This response to the Lower Lea Crossing consultation is from **Newham Cyclists**, the local borough group of the London Cycling Campaign (LCC). We are a grassroots volunteer group who exist to help all kinds of people access cycling as a cheap, accessible, and convenient form of transport.

## **ASPEN WAY ROUNDABOUT**

## LOWER LEA CROSSING

## **LIMMO ACCESS BRIDGE CROSSOVER & TIDAL BASIN ROUNDABOUT**

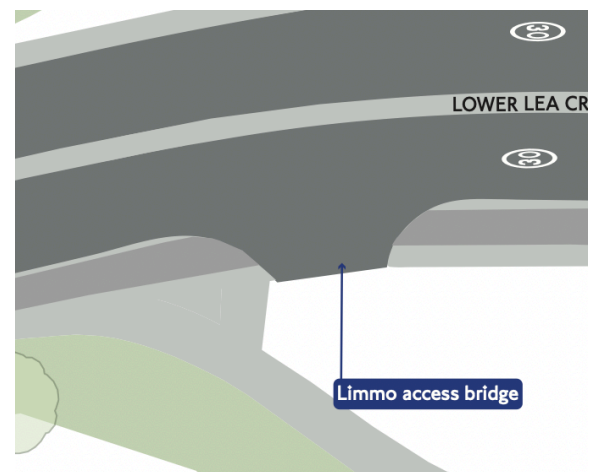
**Silvertown Tunnel scheme. We understand that the Tidal Basin Roundabout is beyond the scope of this consultation (in fact, we have not been consulted on the design for it at all.) However, we believe it is pertinent as this is what the Lower Lea Crossing scheme connects to on its east end, and so those hoping to use the consulted scheme to head to City Hall or the Royal Docks will then need to navigate it.**

We note the proposed interruption to the footway and cycle track for the Limmo access bridge.

Priority arrangements are not explicitly indicated in the consultation material. We are concerned that service vehicles entering this access bridge will do so at speed and without giving way to people walking and cycling. Such vehicles are likely to be large, and potentially carrying industrial material. Larger vehicles may well also have worse visibility, even where they conform to the Direct Vision standard.

We suspect, having obtained the detailed designs and a report from Riverlinx on the design of Tidal Basin Roundabout<sup>2</sup> that the intention is the footway and cycleway will **not** have priority at this crossover, likely with deference to the Design Manual for Roads and Bridges, a motorway design manual which prioritises motor traffic throughput and speed to the detriment of those walking & cycling.<sup>3</sup>

**We do not consider this appropriate for the key cycle link from City Hall and the Royal Docks to central London.** Junctions of this design—where those walking and cycling are expected to give way, and often with compromised visibility—are known to be dangerous. Less than one mile away from this scheme is North Woolwich Road, which, until it was rebuilt as part of the Royal Docks Corridor scheme, had a two-way cycle track that ceded priority to side roads which were heavily trafficked by service and construction vehicles. This

- **At a bare minimum, there must be very clear markings on the crossovers of the Limmo access bridge—symbols, coloured surfacing, and signage—to indicate to drivers that they are crossing a cycle track and footway, and must anticipate people walking and cycling.** Under the Highway Code, drivers are supposed to give way when turning anyway.
- Within the constraints of an “urban motorway” type design prescribed by DMRB, we **insist** that all measures possible are taken to warn drivers of servicing vehicles that they need to look out for vulnerable road users.
